WATER LICENCE INSPECTION FORM

Licensee	Licensee Representative
2BB-MEL1424	Phillip Roy
Licence No. / Expiry	Representative's Title
July 21st, 2024	Environmental Technician
Land / Other Authorizations	Land / Other Authorizations
2BW-MEL1525	N2013C0002
Date of Inspection	Inspector
June 9 th , 2015	WRO Wilson
Activities Inspected	
<div><input checked="" type="checkbox"/> Camp<input type="checkbox"/> Drilling<input type="checkbox"/> Mining<input type="checkbox"/> Construction<input type="checkbox"/> Reclamation<input type="checkbox"/> Fuel Storage</div> <div><input checked="" type="checkbox"/> Roads/Hauling<input checked="" type="checkbox"/> Other: Water Discharge<input type="checkbox"/> Other:</div>

PHOTO LOG

Date:	Authorization Number:	Camera/Model:	Inspector
June 9 th , 2015	2BB-MEL1424	Sony DSC-HX50V Cyber shot	WRO Wilson
Locations name:		Lat/Long (DD.MM.SS.SS, NAD83)	
Photo 1		N63° 1' 36.47", W92° 12' 40.433"

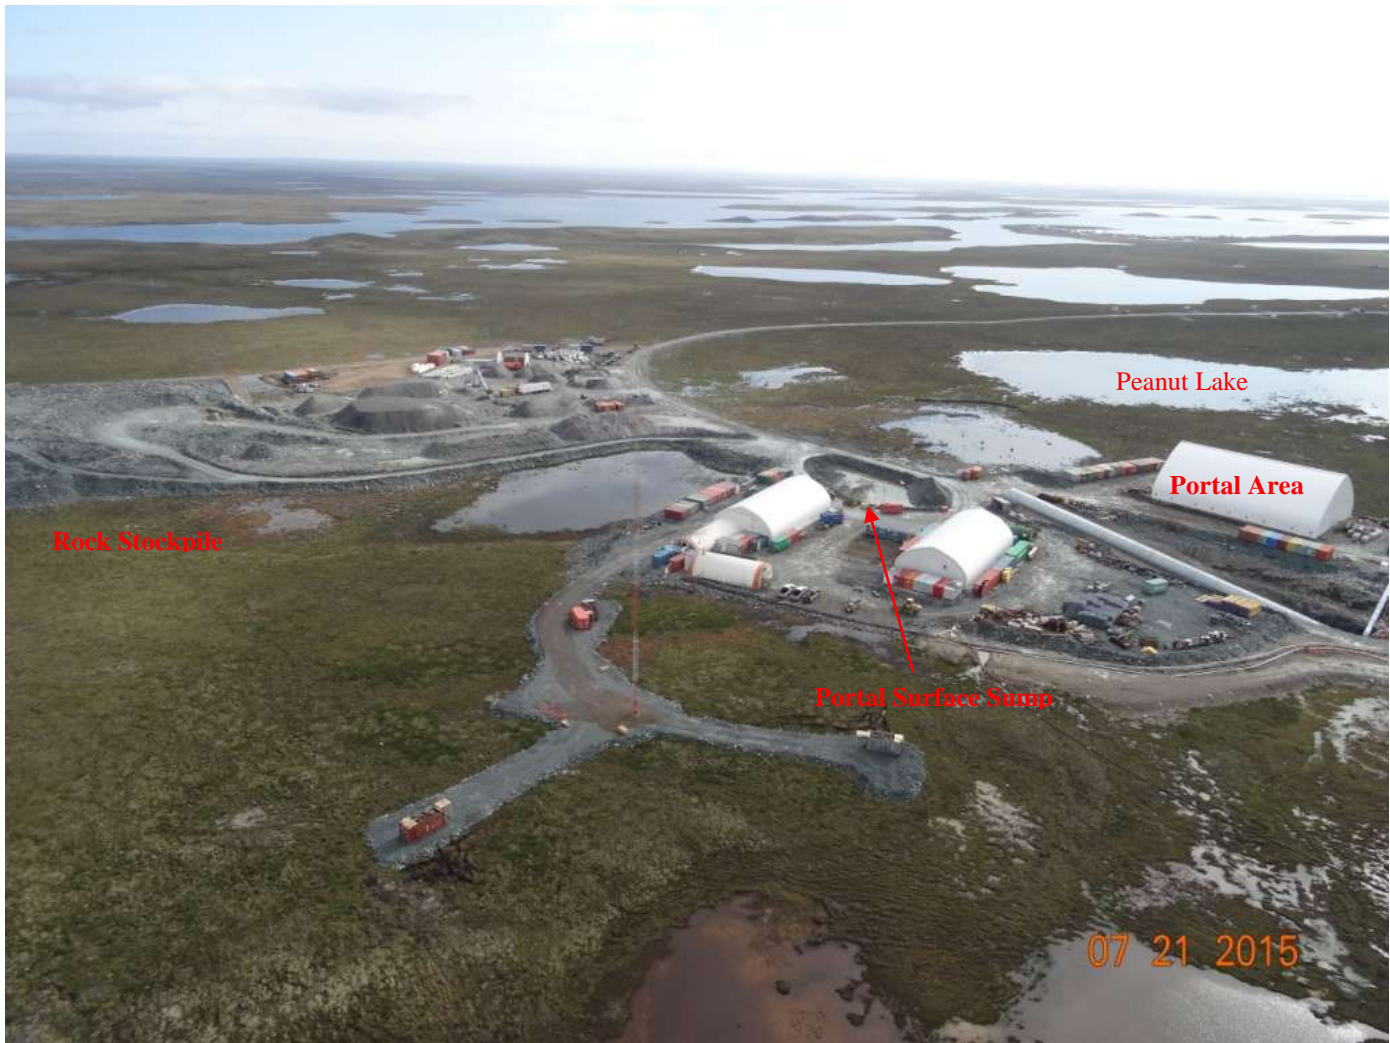
Descirption:
Portal Surface Sump
